SUBJECT: Beaver Valley Power Station - Unit No. 2  
Docket No. 50-412  
Response to Draft SER Open Item No. 173

Draft SER Open Item No. 173 (Sections 2.5.4.3.1, 2.5.4.3.4, 2.5.5.1, 2.5.5.2, 2.5.5.3, and 2.5.5.4) - Stability Analyses:

FIGURE 173-1  
RIVERWARD SLOPE STABILITY  
DYNAMIC CASE  
BEAVER VALLEY POWER STATION-UNIT 2  
STONE & WEBSTER ENGINEERING CORPORATION

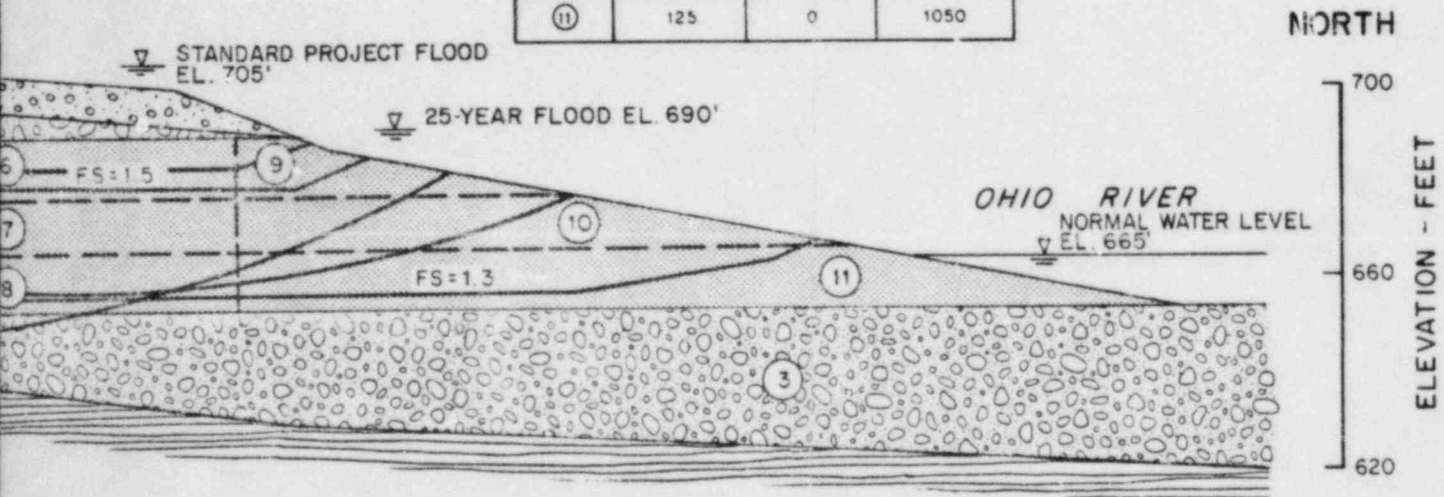
The applicant analyzed the static and dynamic slope stability of the riverward slope north of the EOS for the combined loading of SSE and the normal water level at el 665 ft. The safety factors in the static and dynamic cases were 1.6 and 1.2, respectively. The SRP, Section 2.4.4, recommends that analyses be made for two combined

loading conditions, namely, SSE + 25-year flood (el 690 ft), and OBE + standard project flood (el 705 ft). The applicant has stated that groundwater levels in the clay layer of the riverward slope would not change substantially during the relatively short duration of the 25-year flood. Therefore, the applicant has assumed that it is acceptable to consider failure surfaces through the clay layer with the groundwater level corresponding to the normal river water level at el 665 ft. rather than 690 ft. Because of the presence of cohesionless soil layers with greater permeability than that of clay layer in the riverward slope, the staff requires that the applicant perform stability analyses for the two loading conditions described above. We will report the results of our evaluation of this matter in the final SER.

Fig. 173-1 presents the results of the stability analysis of the EOS riverward slope. This section corresponds to Fig. 6-5 of the SWEC report entitled, "Stability of Slopes at the Emergency Outfall Structure," June 1983. The OBE + standard project flood condition was not previously analyzed. Since the cohesionless material above the clay layer will be partially saturated during the standard project flood, the stability of the upper slope may be affected. Therefore, an additional analysis was performed for the OBE + standard project flood condition, as shown on Fig. 173-1, resulting in a minimum factor of safety of 1.3, which is satisfactory.

The stability of failure surfaces passing through the clay layer will not change by raising the water level from normal water conditions to the 25-year flood level. As stated in the 1983 SWEC report, the short-lived flood conditions will not reduce the strength properties of the clay nor will it affect the sand and gravel above the clay layer. A failure surface below the clay layer through the sand and gravel was analyzed for the SSE + 25-year flood condition and the factor of safety resulting from this analysis was also found to be satisfactory.
